December 6, 2017
Allies & Ross Management and Development Company
IFB#2017-22 –E-P-H

**OCCUPIED RENOVATION OF GLEN HAZEL (BERNICE CRAWLEY) HIGHRISE
(AMP-33) / GLEN HAZEL FAMILY COMMUNITY (AMP-32)**

ADDENDUM NO. 3

L104B and L204A

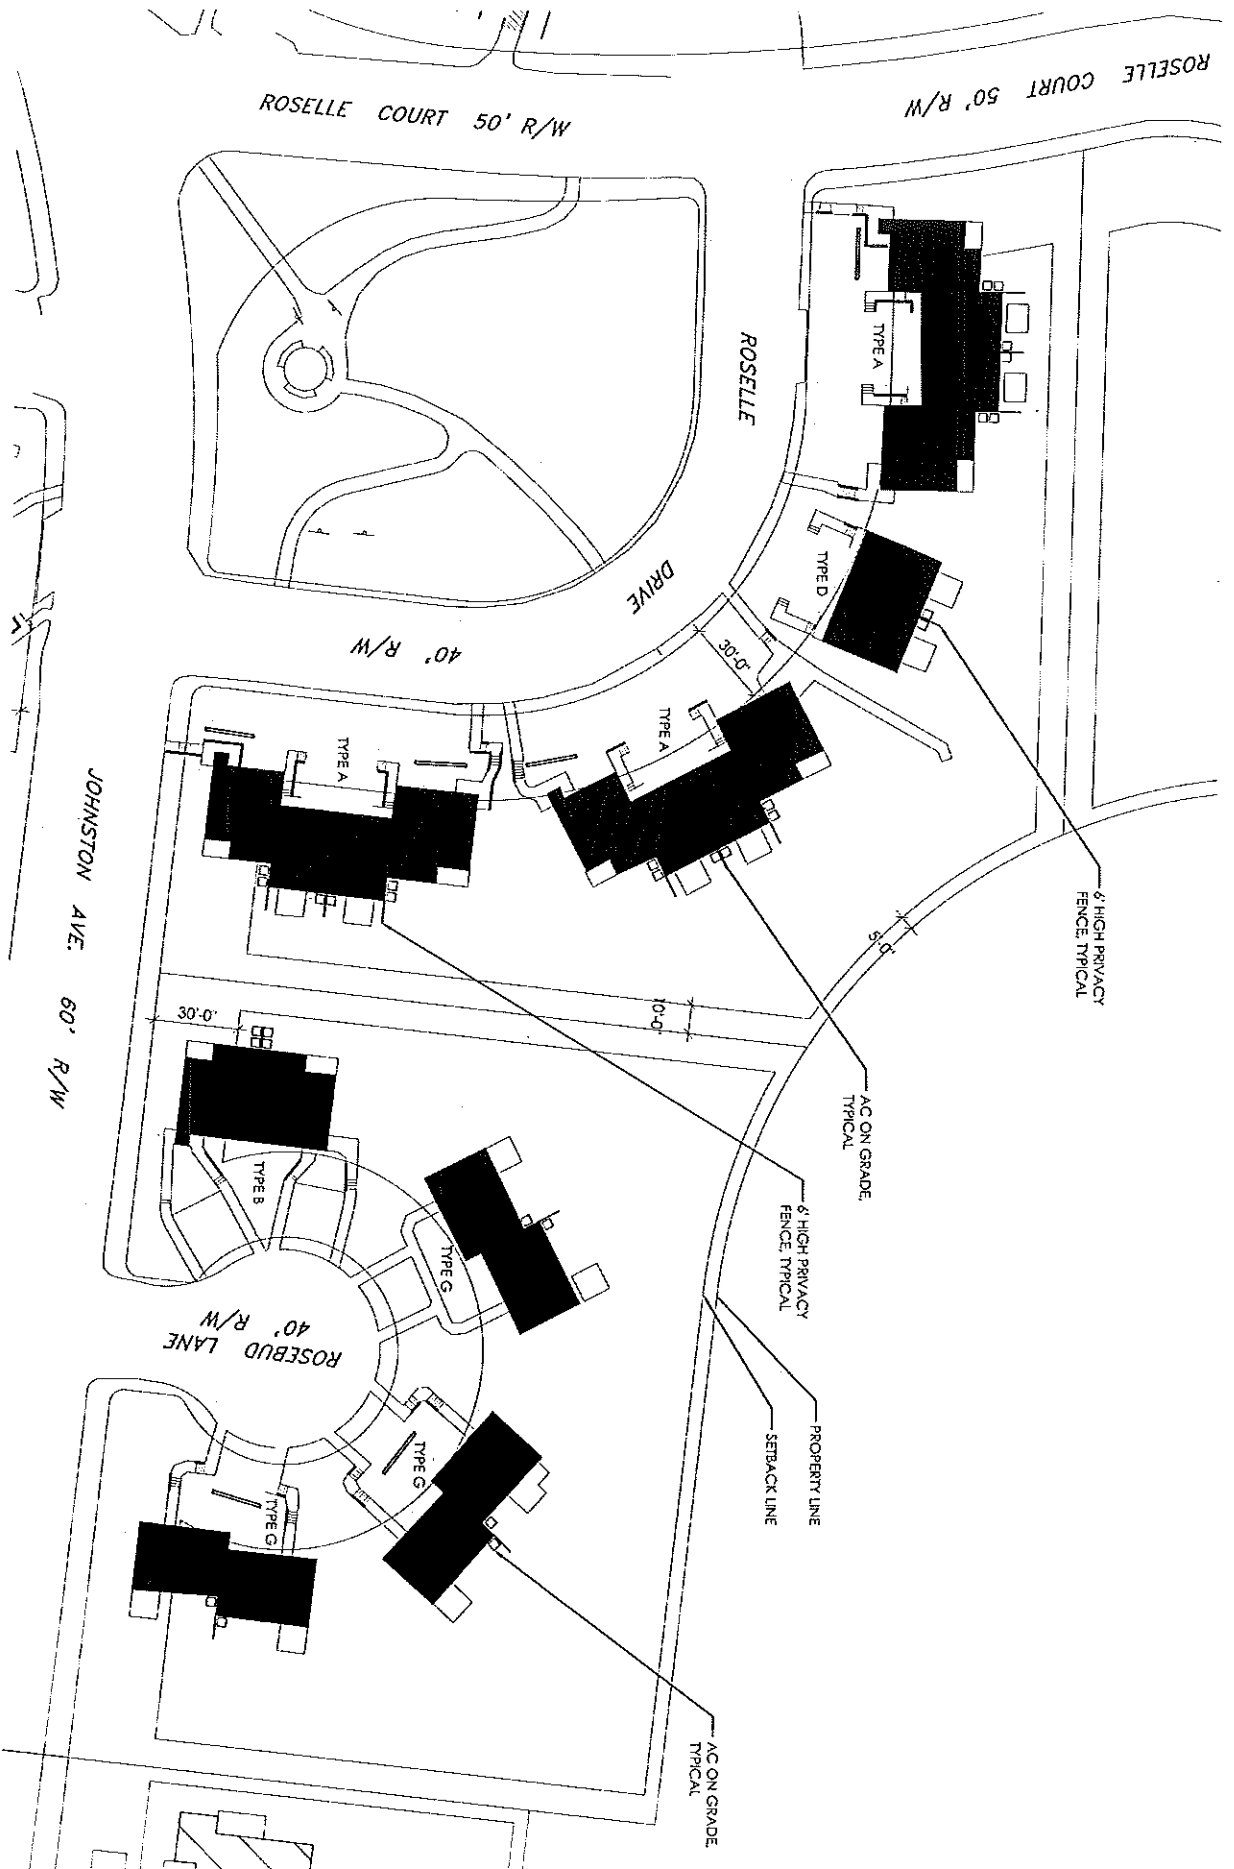
Item 12: Q: The following drawings are listed on the cover page (Dated October 27, 2017) but not available on the website to download:

L-101B Privacy Fence and Mechanical Equipment Pad Location Plan
L-102B Privacy Fence and Mechanical Equipment Pad Location Plan
L-103B Privacy Fence and Mechanical Equipment Pad Location Plan
L-104B Privacy Fence and Mechanical Equipment Pad Location Plan
L-105B Privacy Fence and Mechanical Equipment Pad Location Plan
L-106B Privacy Fence and Mechanical Equipment Pad Location Plan
L-107B Privacy Fence and Mechanical Equipment Pad Location Plan
L-108B Privacy Fence and Mechanical Equipment Pad Location Plan
L-109B Privacy Fence and Mechanical Equipment Pad Location Plan

Please advise.

A: **Drawings were mislabeled, corrections have been done. Attached are pages L104B and L204A, which have also been uploaded, and are now available for viewing and download on the Housing Authority City of Pittsburgh website: www.HACP.org.**
